SUBJECT: Wilson County, SR 1158 (Airport Blvd) from North of NC
42 to US 264; T.I.P. Number U-3823; Federal Aid Project
STP-1158(2); State Project 8.2341801

Please reference the Department of the Army permit issued to you on January 4, 2006, for Sections A and B of the S.R. 1158 (Airport Road) TIP U-3823, adjacent to Bloomery Swamp and two unnamed tributaries, from NC 42 to US 264A, West of Wilson, in Wilson County, North Carolina. The Corps is issuing this permit modification in response to your written request of June 14, 2007. The permit modification requests are as follows:

Subject: Modification to the 401 Water Quality Certification Pursuant to Section 401 of the Federal Clean Water Act and NEUSE BUFFER RULES, with ADDITIONAL CONDITIONS for Proposed widening to SR 1158 in Wilson County, Federal Aid Project No. STP-1158(2), State Project No. 8.2341801, TIP No. U-3823. DWQ Project No. 20051764 ver.2.

Modification to the 401 Water Quality Certification Pursuant to Section 401 of the Federal Clean Water Act and NEUSE BUFFER RULES, with ADDITIONAL CONDITIONS

N.C. DEPT. OF TRANSPORTATION
DIVISION OF HIGHWAYS
WILSON COUNTY
U-3823
SR 1158 (AIRPORT BLVD.) FROM
EAST OF NC 42 TO EAST
OF US 264-A
DATE: APRIL 2007
SHEET 1 OF 15

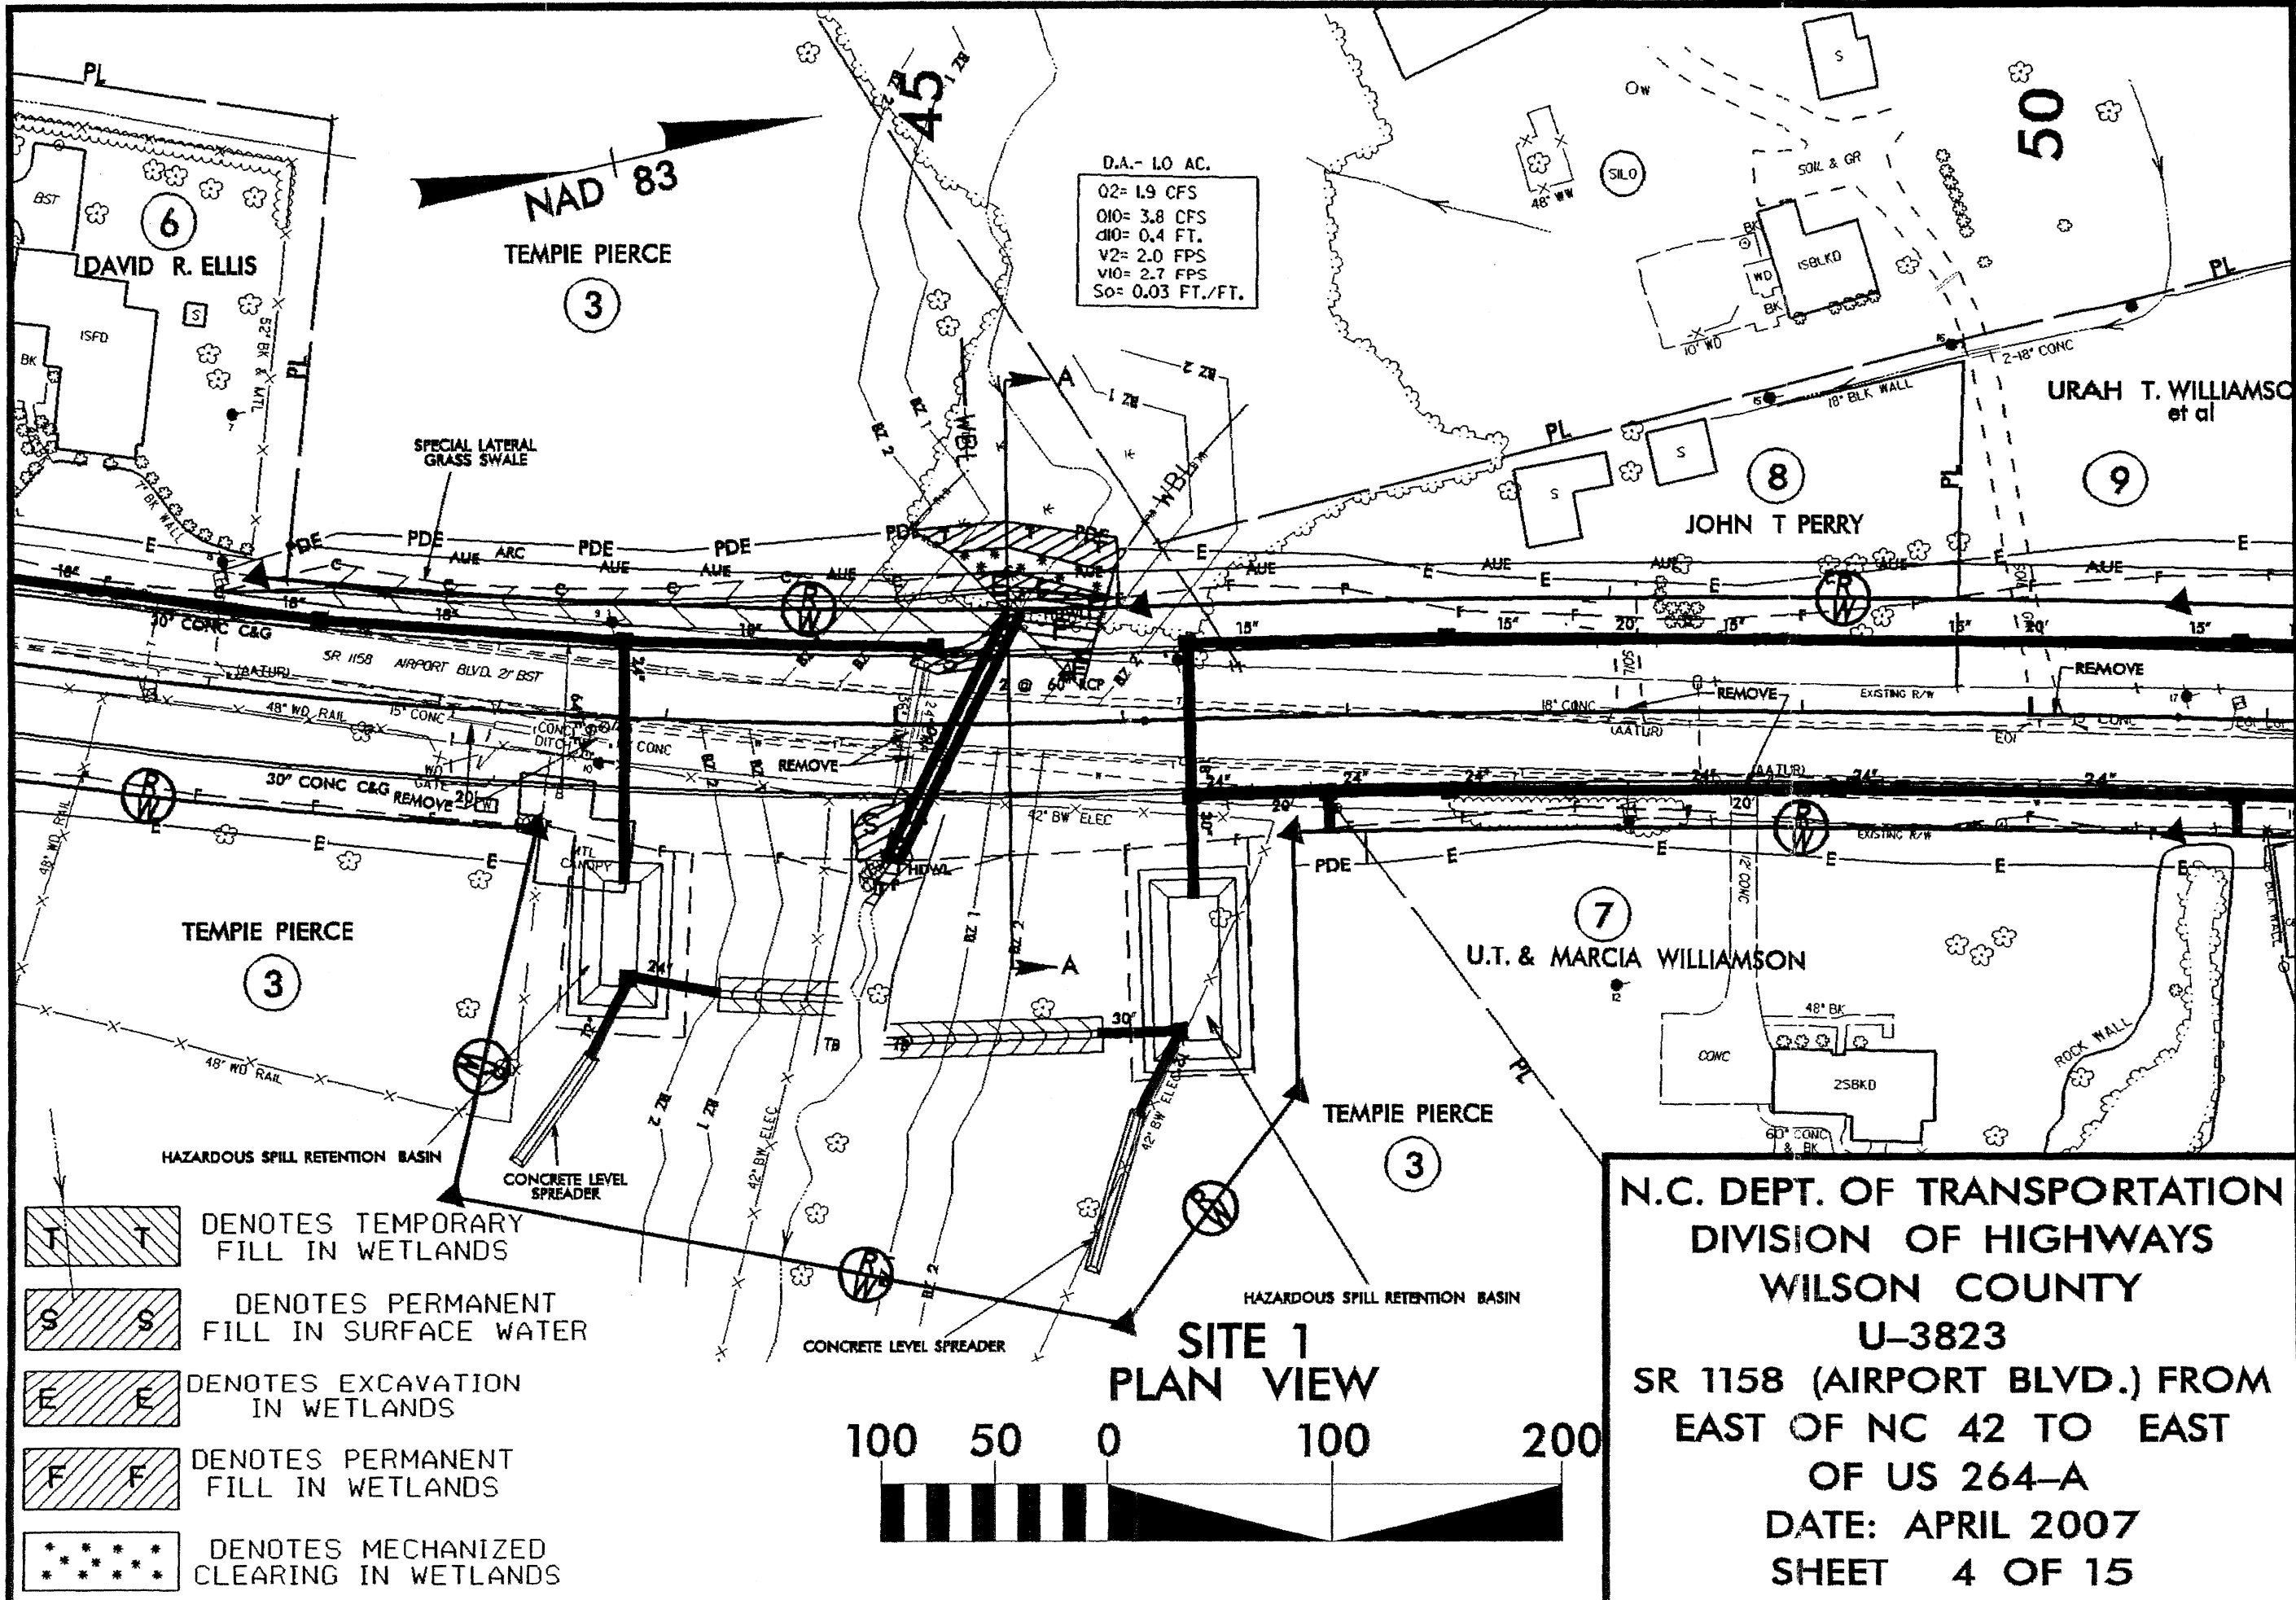
1. Section A, Site 1: Clarify wording to read "temporary fill in wetlands"
2. Section A, Site 2:
 - 0.585 acres of permanent fill in wetlands
 - 0.032 acres of excavation in wetlands
 - 0.268 acres of mechanized clearing in wetlands
 - 0.132 acres of temporary fill in wetlands
 - 0.175 acres of temporary fill in surface waters (workpad)

N.C. DEPT. OF TRANSPORTATION
 DIVISION OF HIGHWAYS
 WILSON COUNTY
 U-3823
 SR 1158 (AIRPORT BLVD.) FROM
 EAST OF NC 42 TO EAST
 OF US 264-A
 DATE: APRIL 2007
 SHEET 6 OF 15

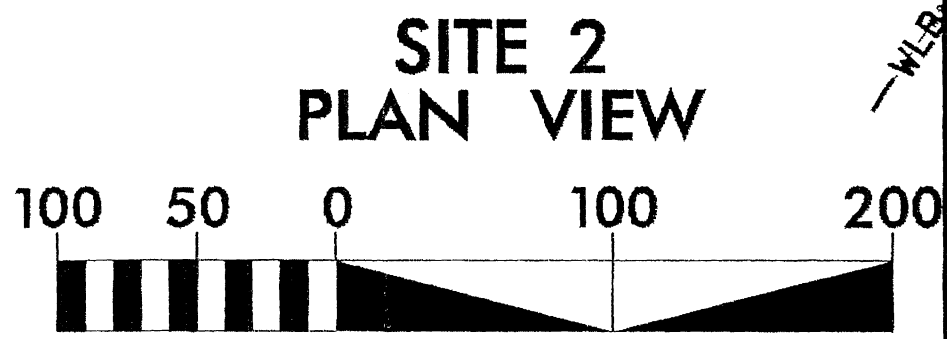
The permit is hereby modified to include the work as indicated above and shown on the enclosed plans. It is understood that all conditions of the original permit remain applicable and that the expiration date is unchanged. It is also understood that the 12-foot by 9-foot pentuple barrel culvert in Section A, Site 2, will be removed in its entirety.
